Addendum

Iowa Department of Transportation Date of Letting: April 17, 2012
Office of Contracts Date of Addendum: April 12, 2012

B.O.	Proposal ID	Proposal	County	Project Number	Addendum
		Work Type			
011	78-0293-080	BRIDGE	POTTAWATTAMIE	IM-NHS-029-3(80)5203-78	17APR011.A02
		NEW - STEEL		IM-NHS-029-3(81)5203-78	
		GIRDER

Sheet No. 54:

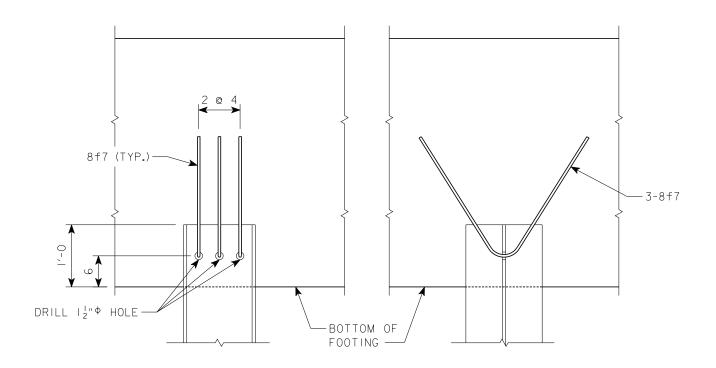
Replace 4 – 8j3 bars with 4 – 8j4 bars and quantity changes from 24lb. to 29lb. Reinforcing Steel, Epoxy Coated – Total at each Abutment changes from 9421 lb. to 9426 lb. *Reinforcing Steel, Epoxy Coated Total at each Abutment changes from 9479 lb. to 9484 lb. *Reinforcing Steel, Epoxy Coated Total for both Abutments changes from 18,958 lb. to 18,968 lb.

PILE UPLIFT ANCHOR DETAIL AT ABUTMENTS

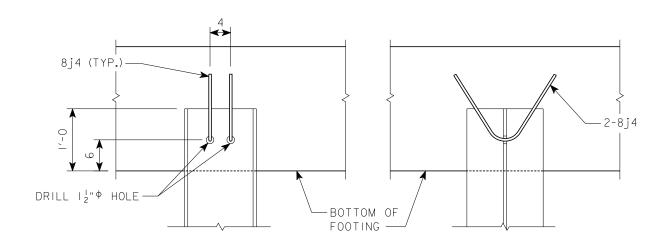
Replace Detail I and Section G-G with Pile Uplift Anchor Detail at Abutments

Replace Detail I and Section G-G with Pile Uplift Anchor Detail at Abutments
